**Economic and Social Council**Distr.: General
11 August 2023

World Forum for Harmonization of Vehicle Regulations**Working Party on Lighting and Light-Signalling****Eighty-ninth session**

UN Regulation No. 10 (Electromagnetic Compatibility)**Proposal for a new 07 series of amendments to UN Regulation No. 10 (Electromagnetic compatibility)****Submitted by the expert from by the Informal Working Group on Electromagnetic Compatibility***

The text reproduced below was prepared by the experts from the Informal Working Group on Electromagnetic Compatibility (IWG EMC), with the aim to develop a new 07 series of amendments to UN Regulation No.10. The proposed modifications to the current text of the UN Regulation are marked in bold for new or strikethrough for deleted characters.

"Figure 1b

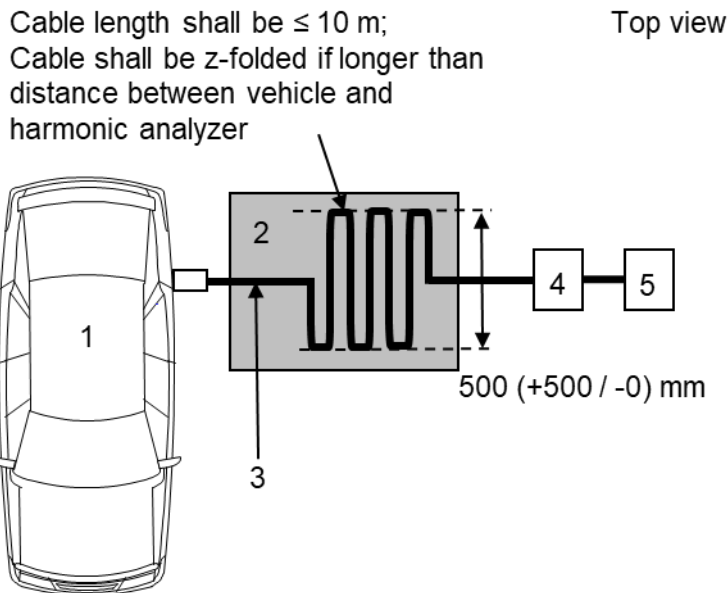
Figure 1b, amend to read:

"Figure 1d

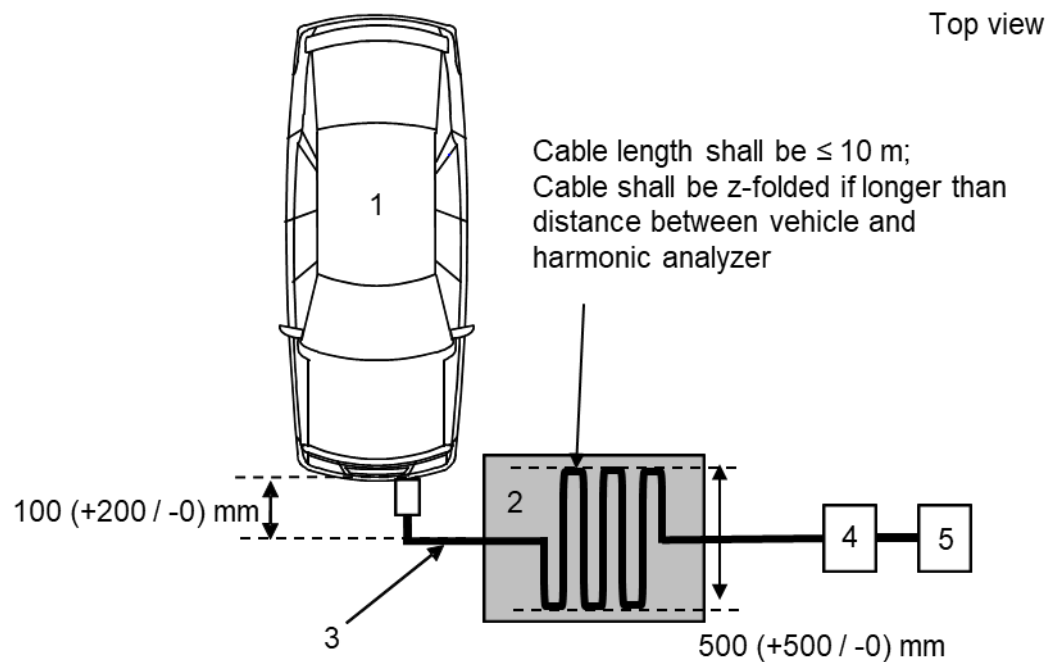
Figure 1d, amend to read:

Figure 1
Charging mode configuration for Annex 12]

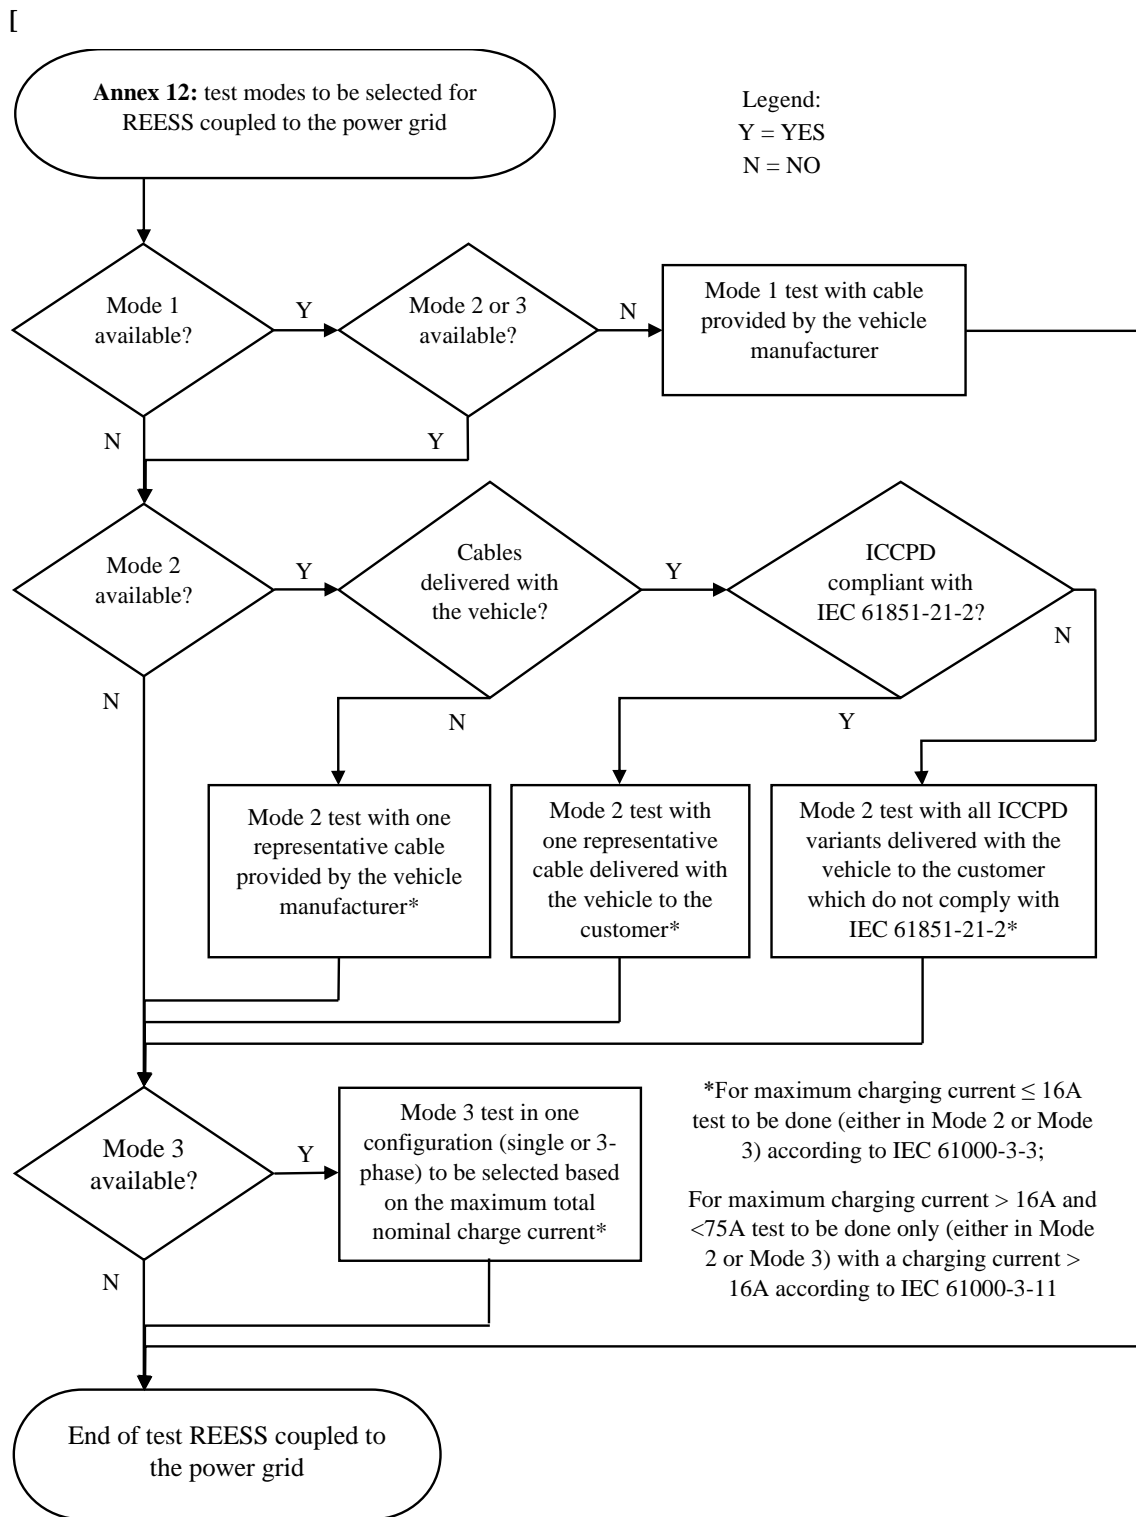
The vehicle shall be tested in the charging mode configuration (if available on vehicle) as defined in flowchart of figure 1

"Figure 1b

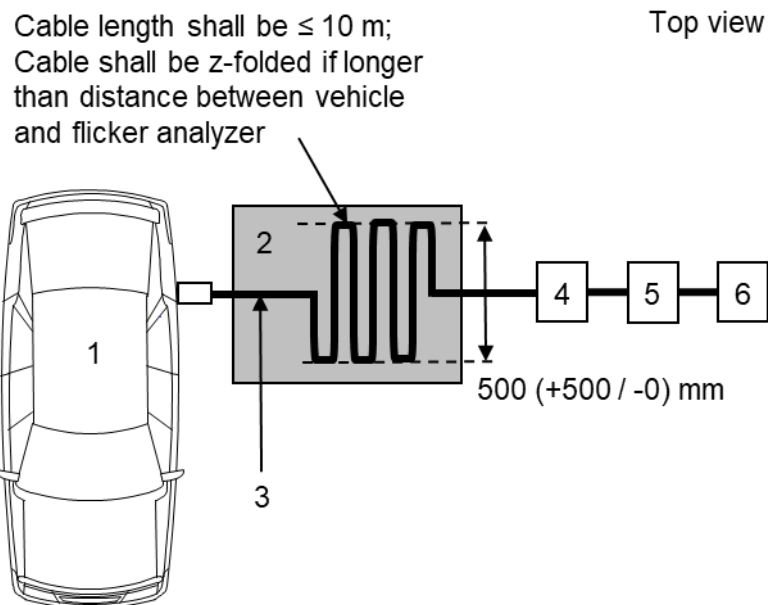
Figure 1b, amend to read:

"Figure 1d

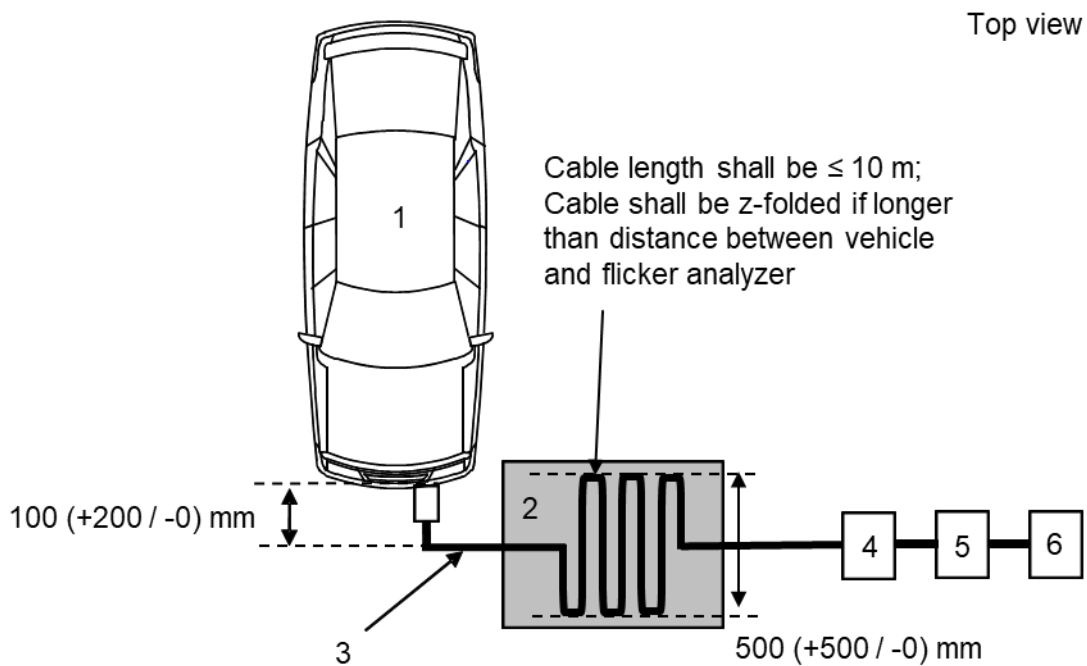
Figure 1d, amend to read:

Figure 1: Charging mode configuration for Annex 13]

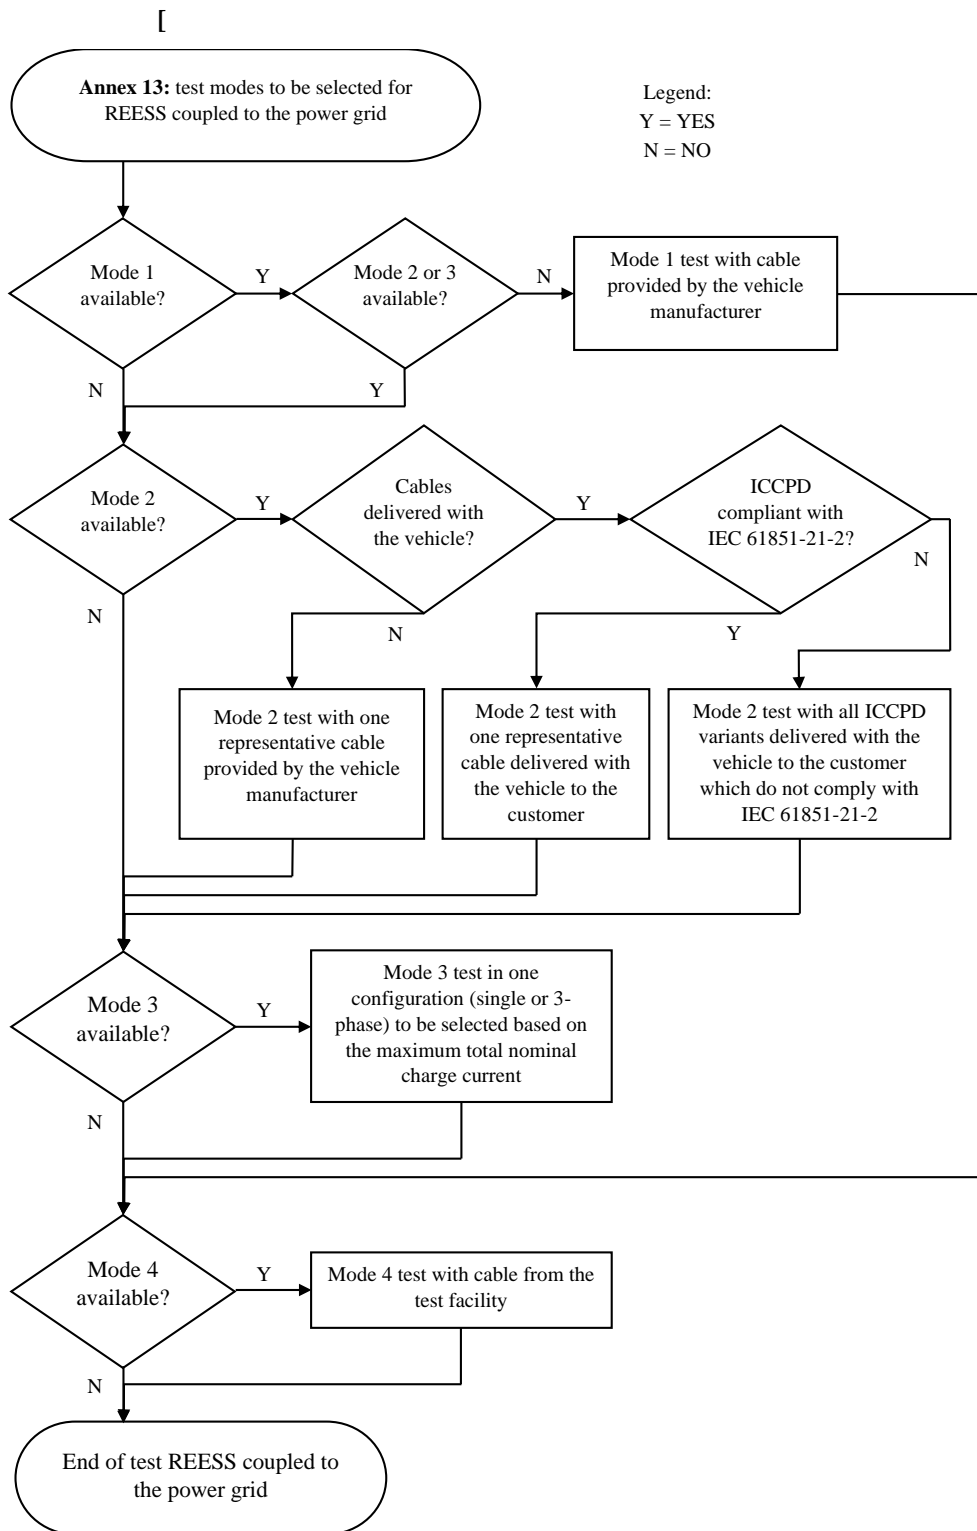
The vehicle shall be tested in the charging mode configuration (if available on vehicle) as defined in flowchart of figure 1

"Figure1b

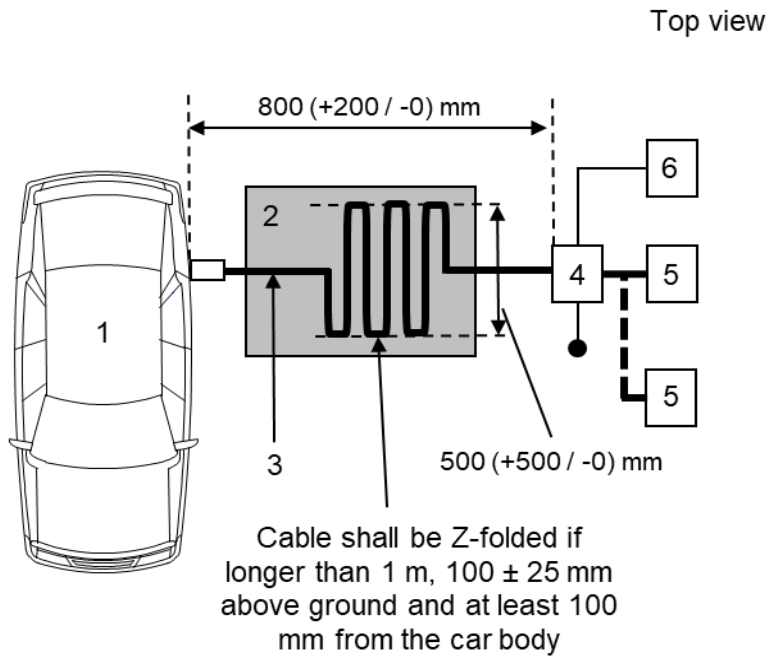
Figure 1b, amend to read:

"Figure 1d

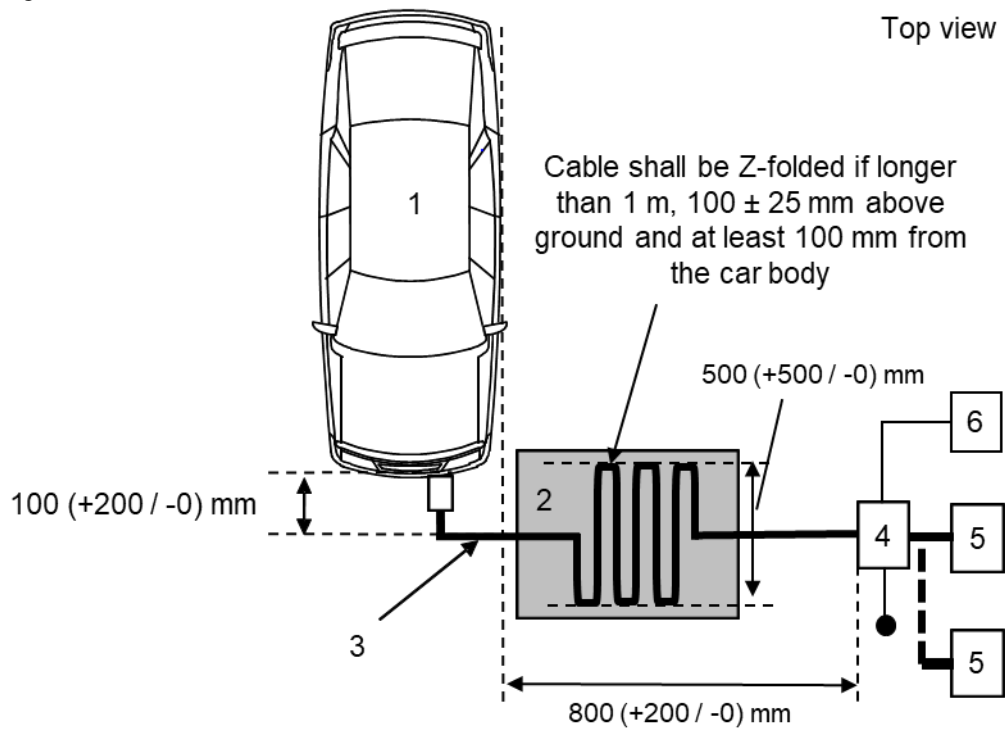
Figure 1d, amend to read:

Figure 1
Charging mode configuration for Annex 15"

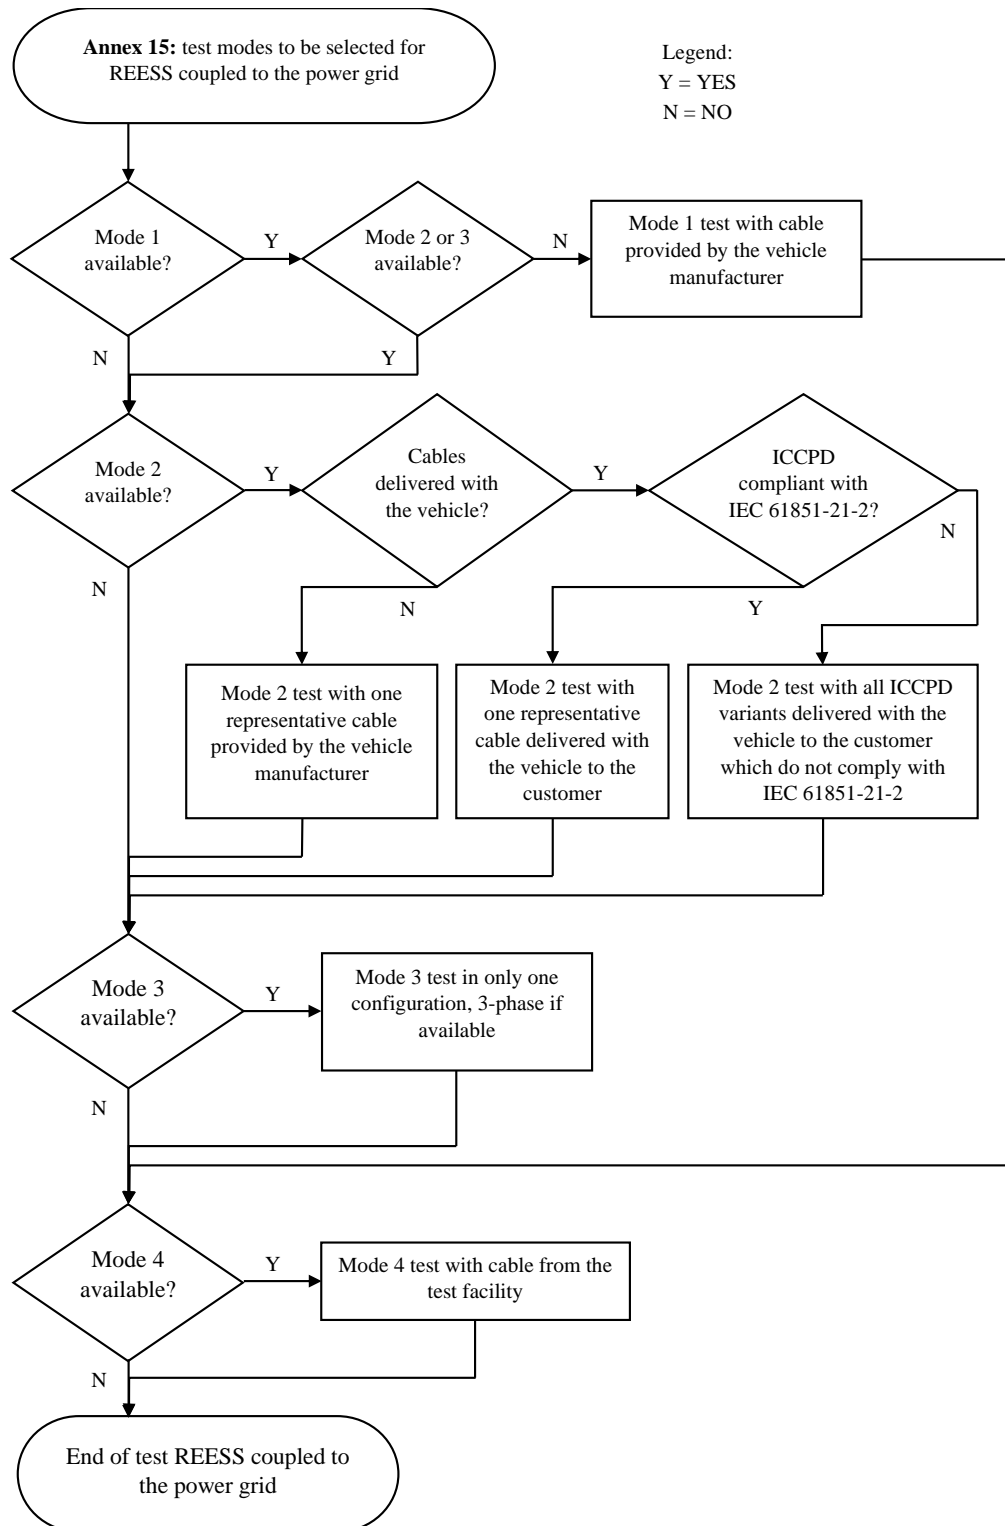
The vehicle shall be tested in the charging mode configuration (if available on vehicle) as defined in flowchart of figure 1

"Figure 1b

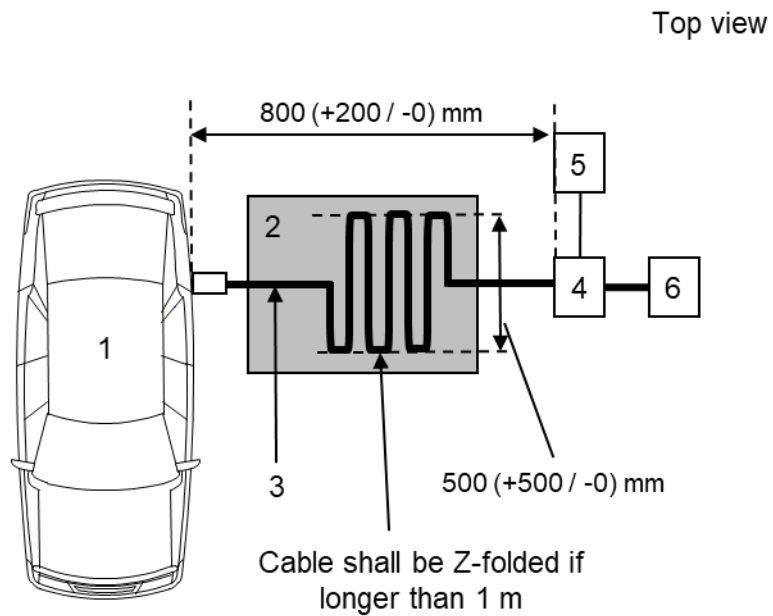
Figure 1b, amend to read:

"Figure 1d

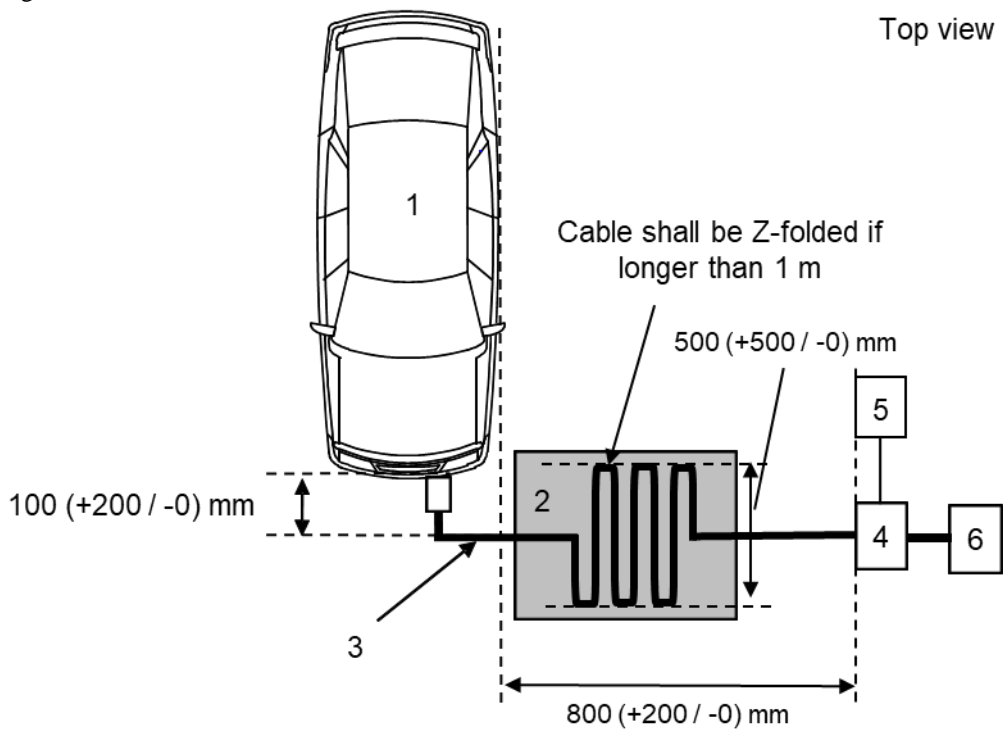
Figure 1d, amend to read:

Figure 1
Charging mode configuration for Annex 16"

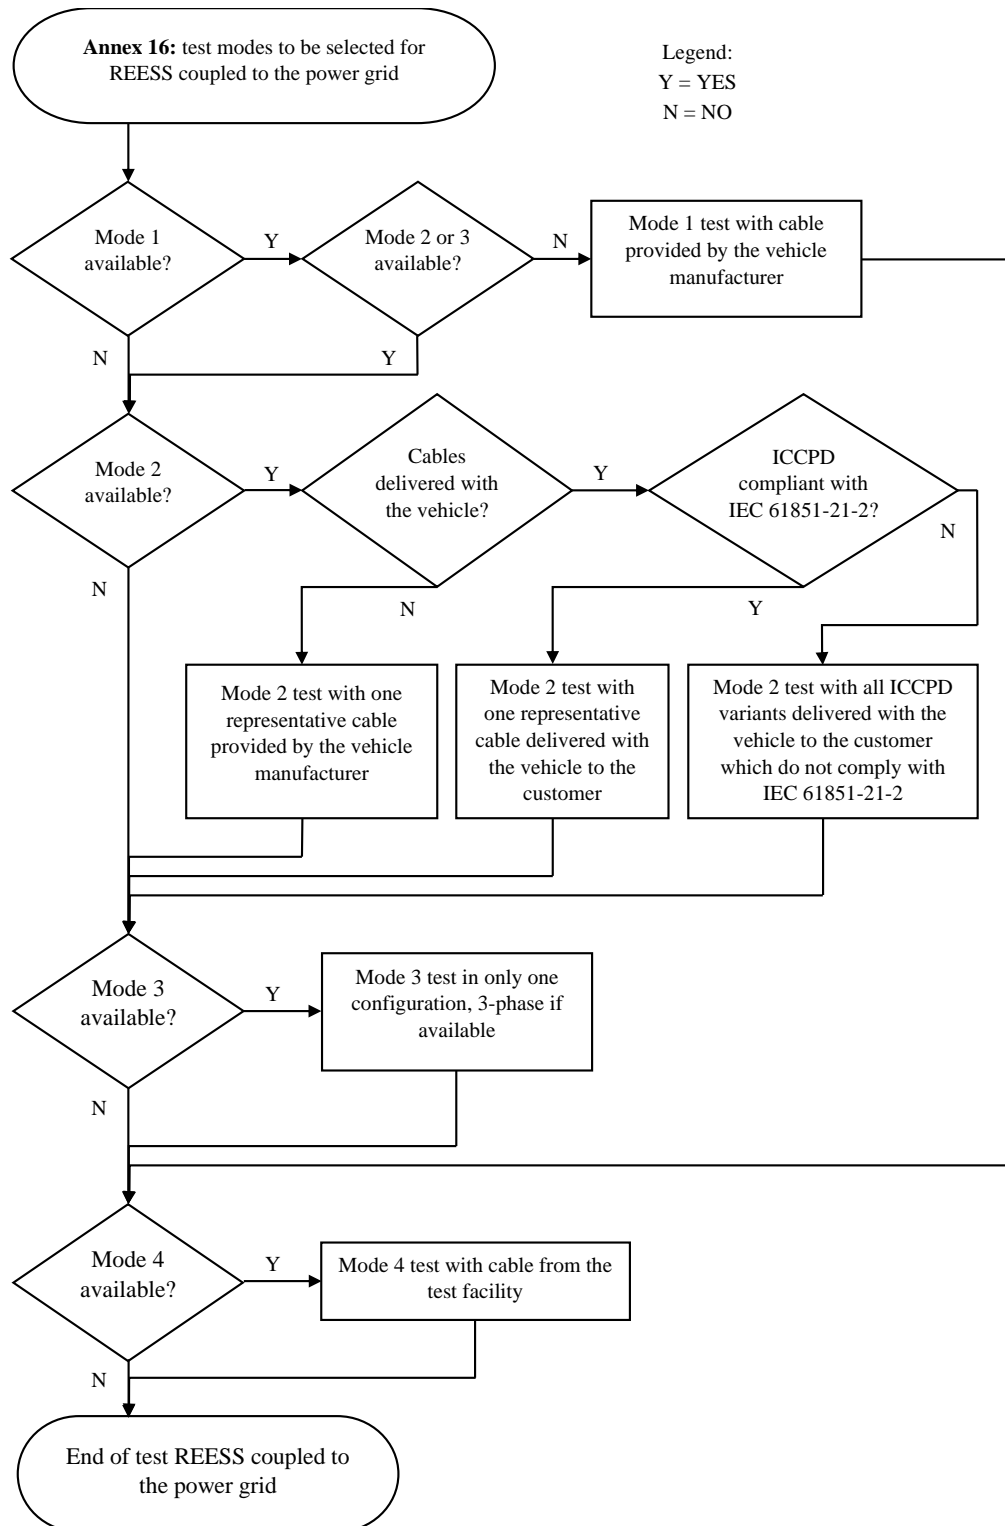
The vehicle shall be tested in the charging mode configuration (if available on vehicle) as defined in flowchart of figure 1
